SUBJECT: January 27, 2026 HISTORIC PRESERVATION COMMISSION MEETING

STAUNTON HISTORIC PRESERVATION COMMISSION

815 West Beverley Street

Install Screen for Side Porch

815. W. BREWER ST
EVALUATED VIEW
OF SCREEN PRCH

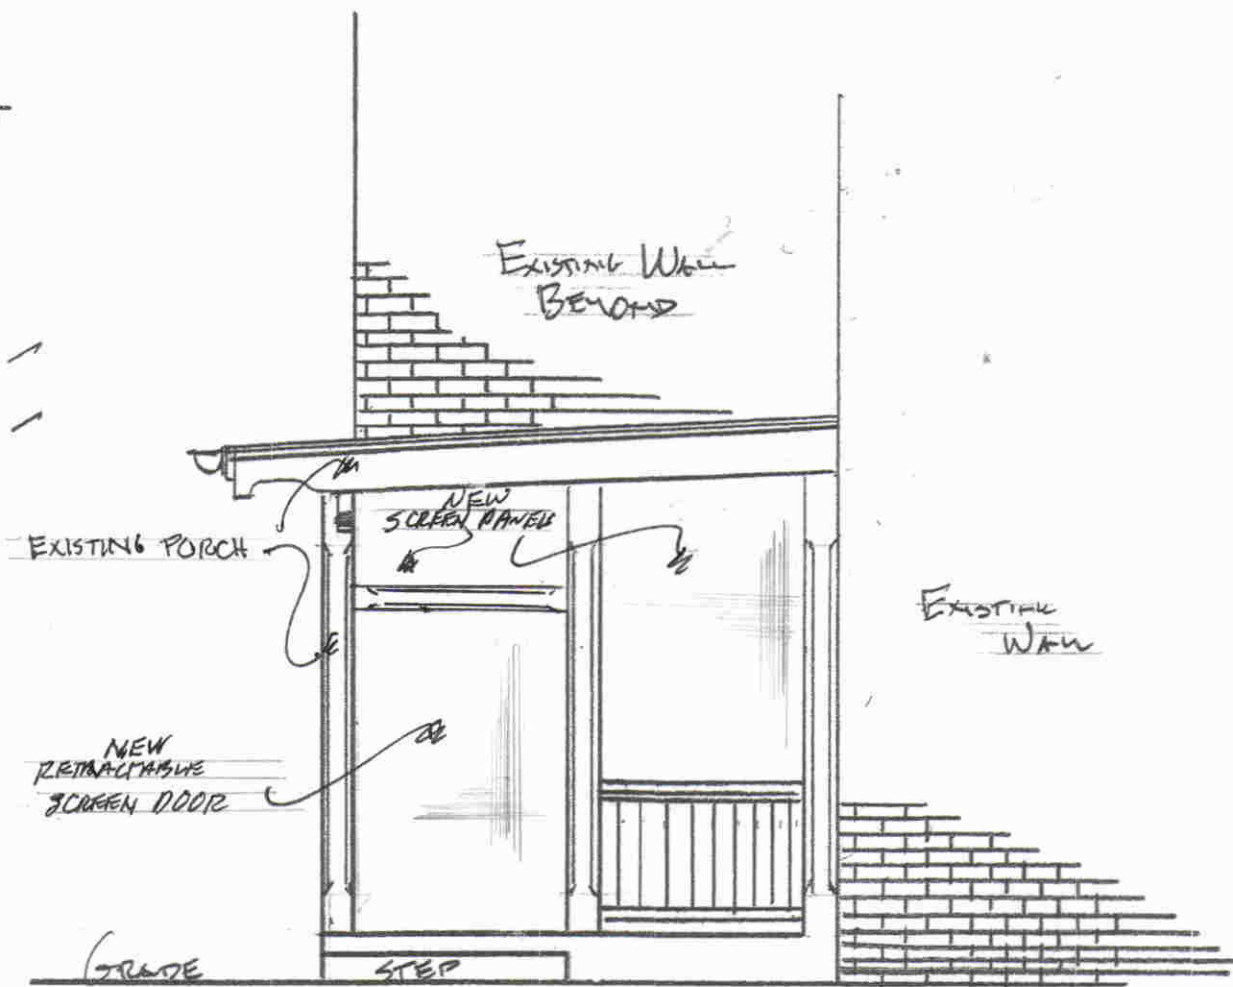
HSF Recommendation: HSF recommends the certificate of appropriateness be approved. The porch is located at the side and toward the rear of the house with limited view. The treatment does not enclose the porch and will not alter the size, scale, or materials of the porch.

Sample Motion: I move the Certificate of Appropriateness be appropriateness be approved as submitted.
